Access Design Assessment Report

Gilgandra Library Plaza Upgrade

Project: Gilgandra Library Plaza Upgrade
Document Type: Access Design Assessment Report
Our Reference: P220_458-1.1 (ACCESS) KG

Drawing Ground Floor Plan **Rev.**

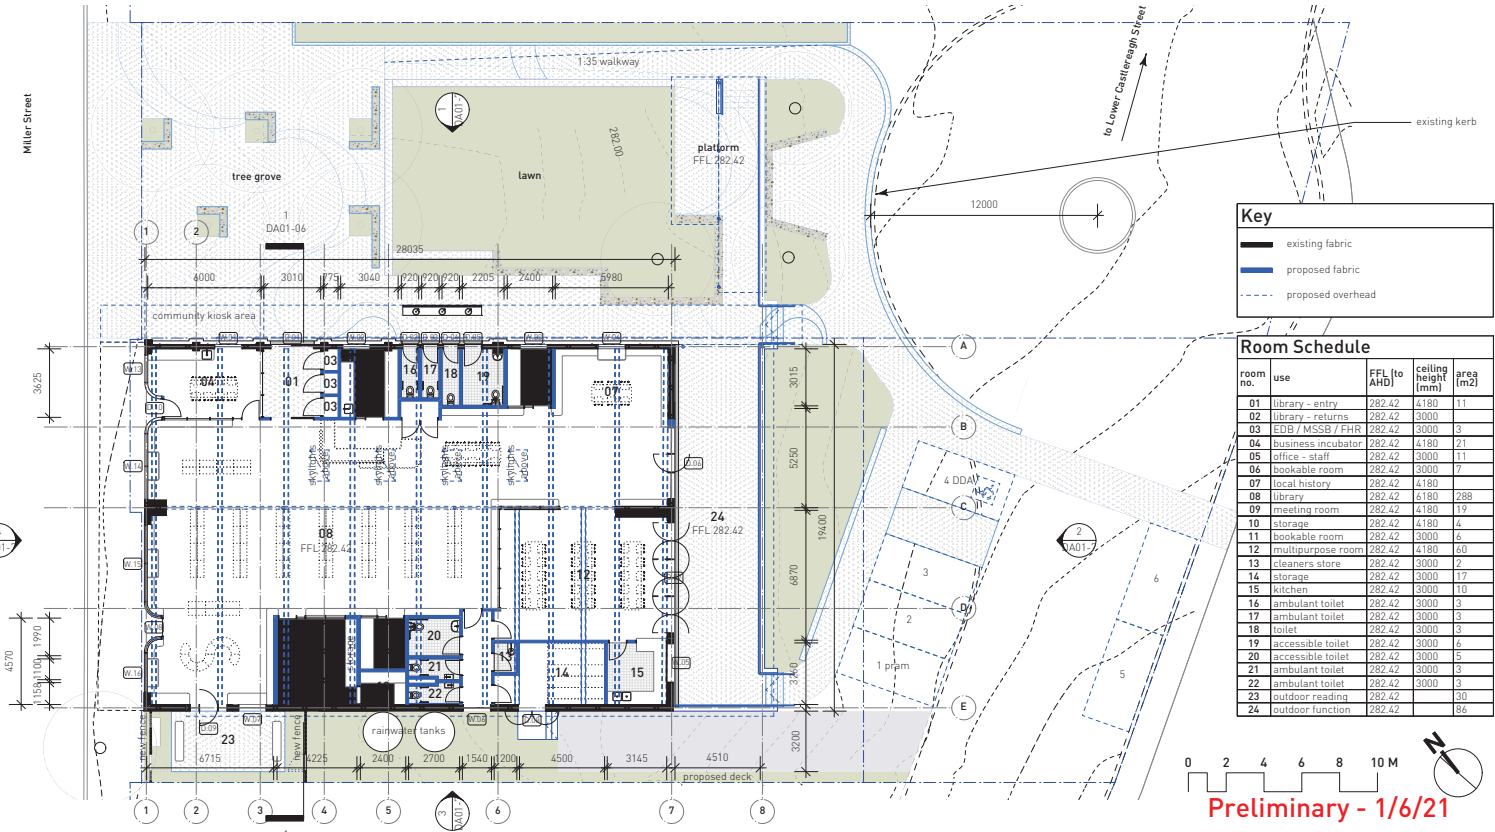
DESCRIPTION	COMPLIANCE DEPARTURE	RESOLUTION
Walkway 1:35	No levels provided for assessment of the walkway.	Provide RL levels on the drawings for further review and comment.
External Stairways	Stairways have not yet been detailed with all the required features and fixings.	Stairway to comply with AS1428.1-2009. Level of detail provided is suitable for this stage. As design progresses, provide detailed drawings for review and comment.

DESCRIPTION	COMMENT	RESOLUTION
General	Signage details have not yet been provided for assessment.	Signage will be required in accordance with the requirements of this clause. Level of detail provided is suitable for this stage. As design progresses, provide detailed drawings for review and comment.

Tactile indicators at stairways have not yet been detailed within the design documentation. Refer to **Appendix 2** below for further design guidance in this regard.
